DEVELOPMENT REVIEW BOARD  
SUPPLEMENTAL SUBMITTAL

PROJECT NO. PR-2019-002277  
Application No. SI-2019-00246

SUBMITTAL DESCRIPTION: DRB Site Plan Resubmittal.

RE: Adagio Apartments  
PR-2019-002277

ADAGIO TOWNHOMES  
 SIX-PLEX  
 Enter address here

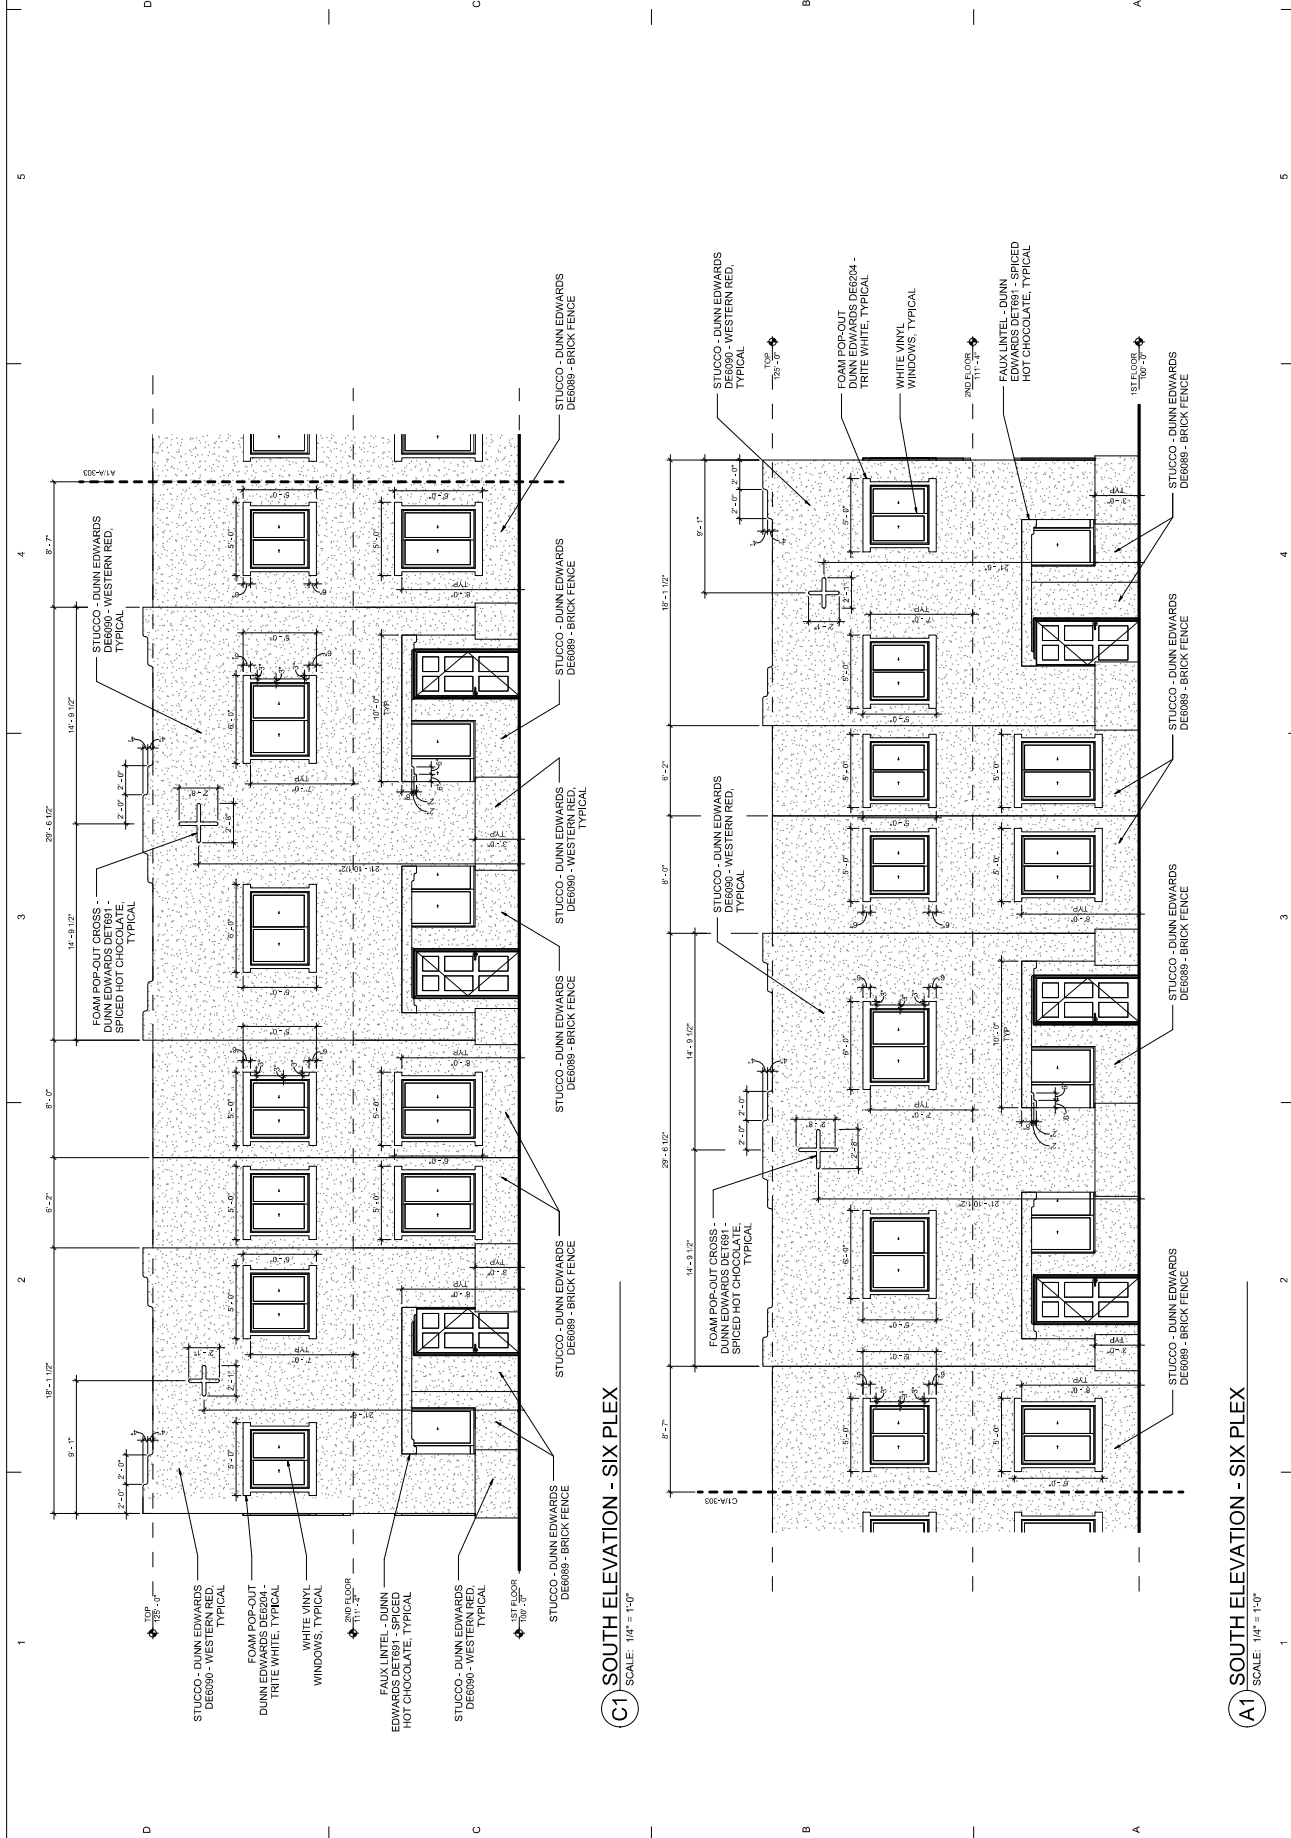
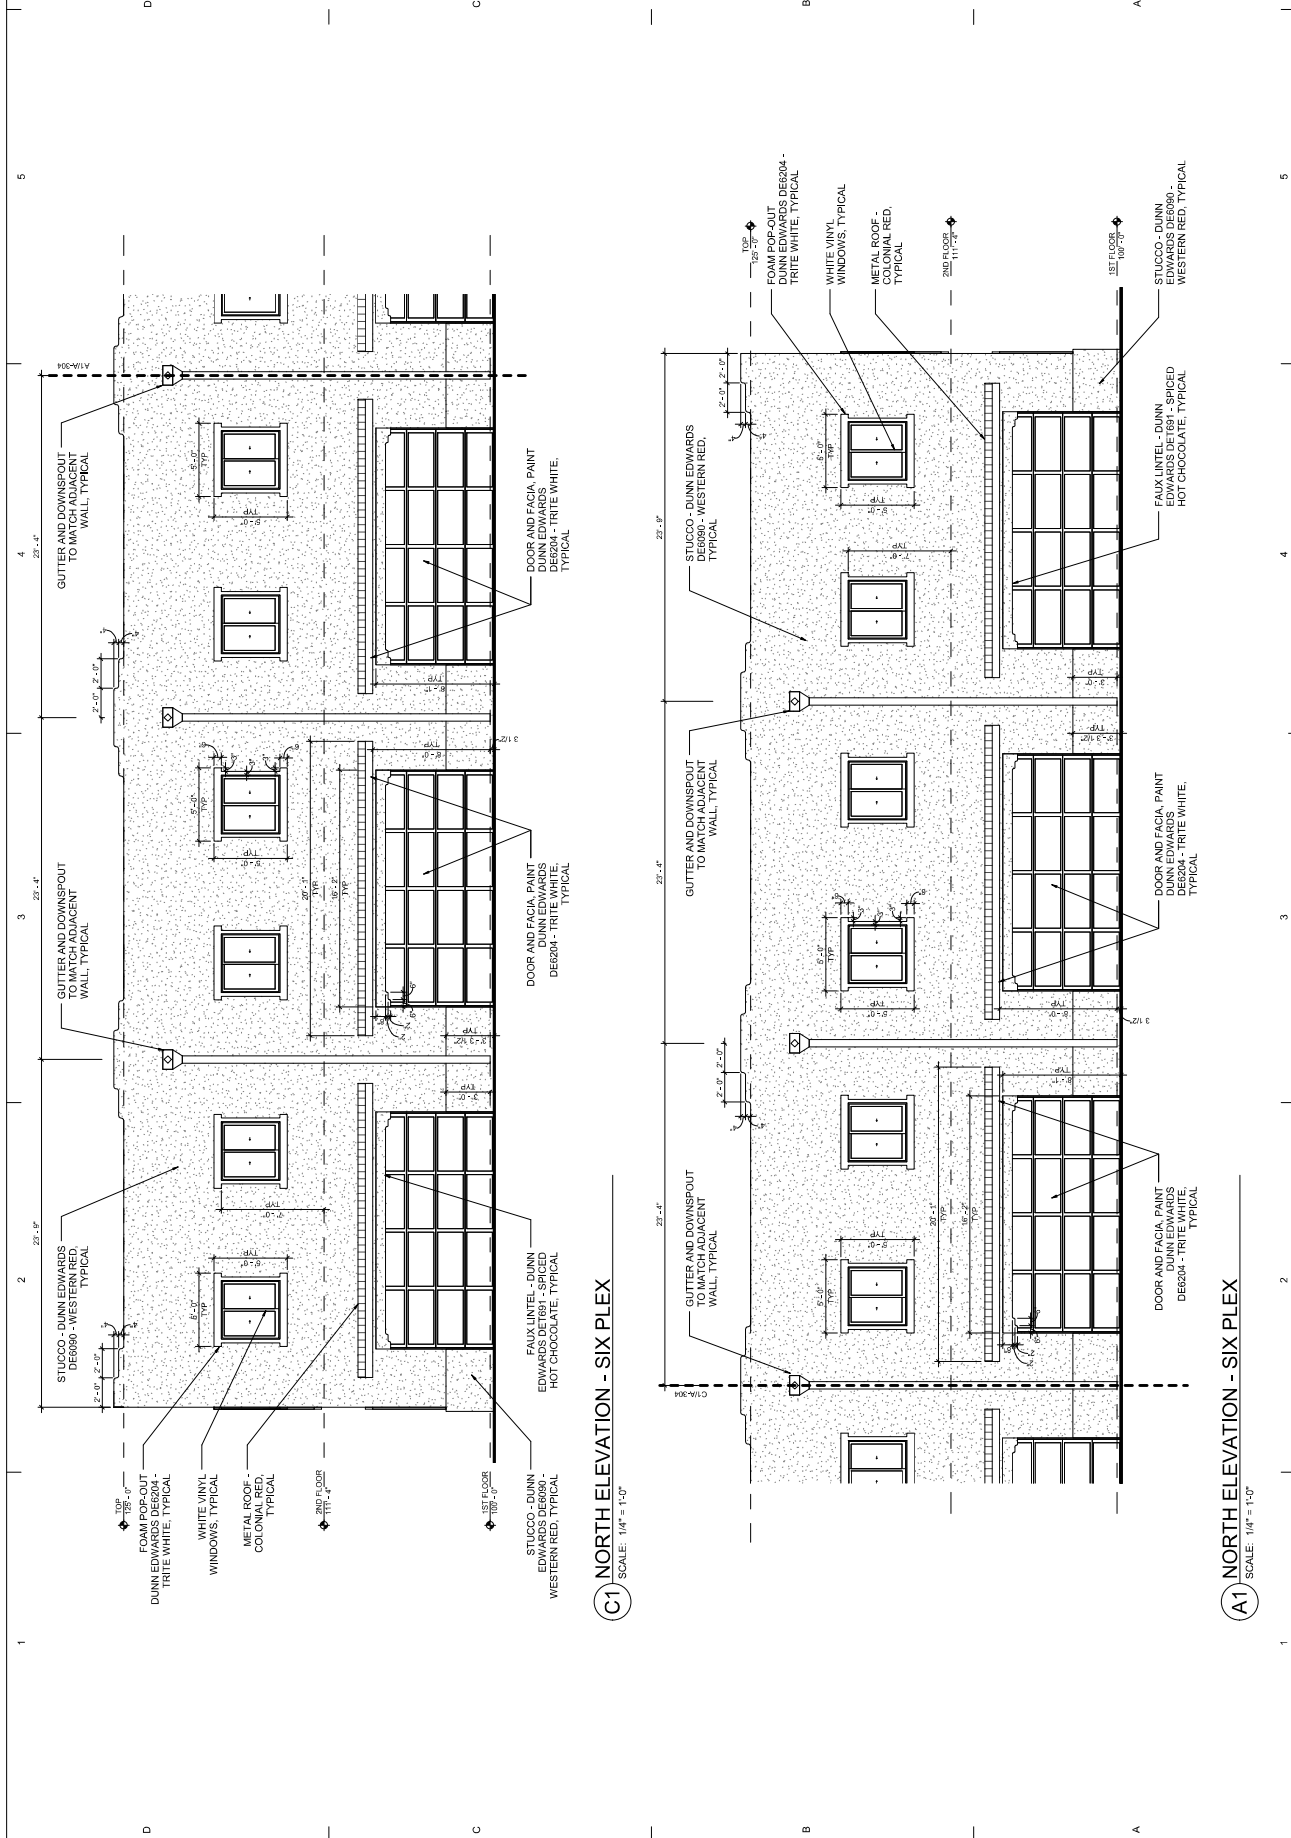
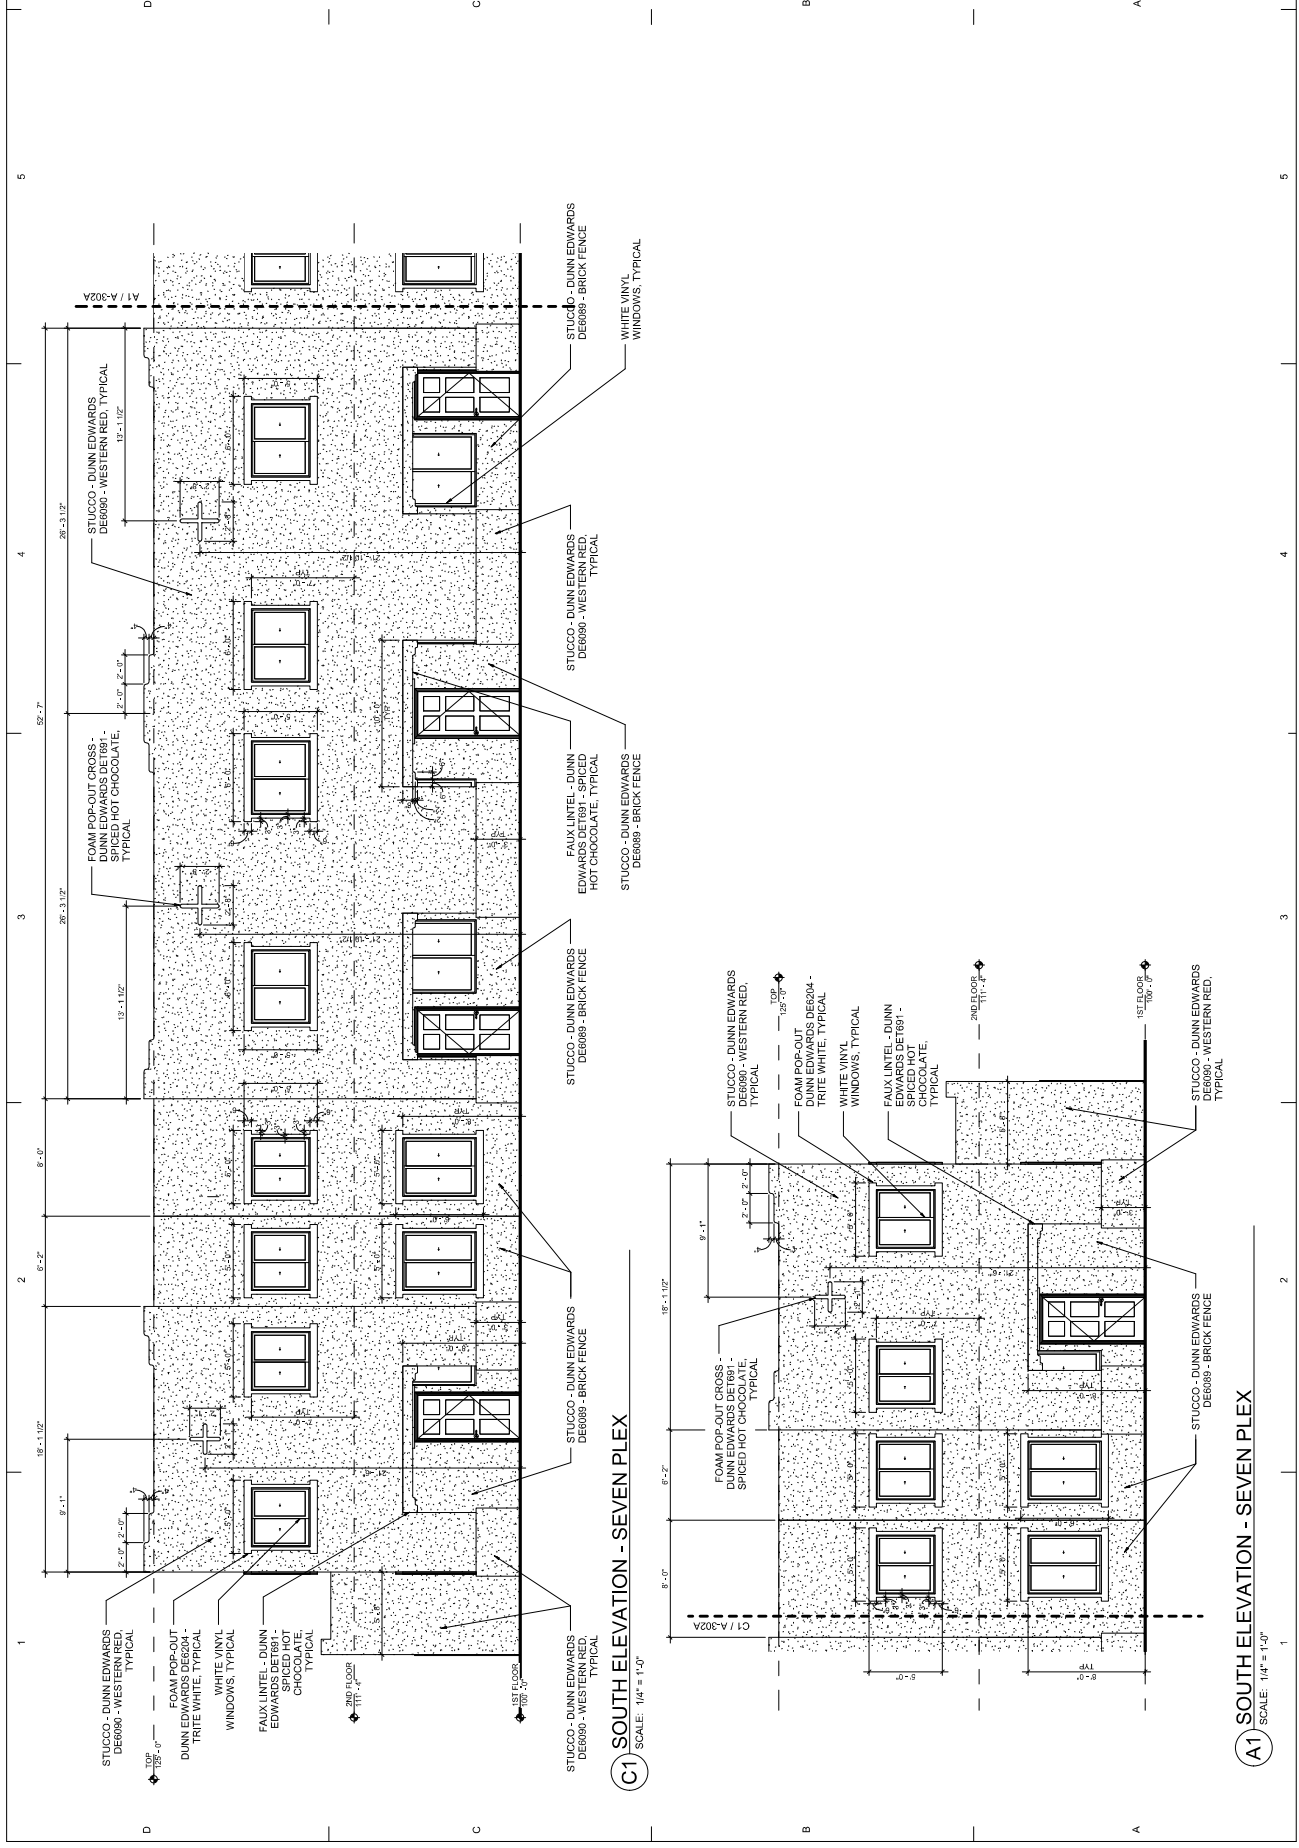
- / The townhomes shall have a color palette consistent with the depiction on the color elevations included in the October 20 supplemental submittal from the applicant.
  - o *Response: I believe this comment was addressed with our last submittal. Regardless, the latest elevations are included with this submittal.*
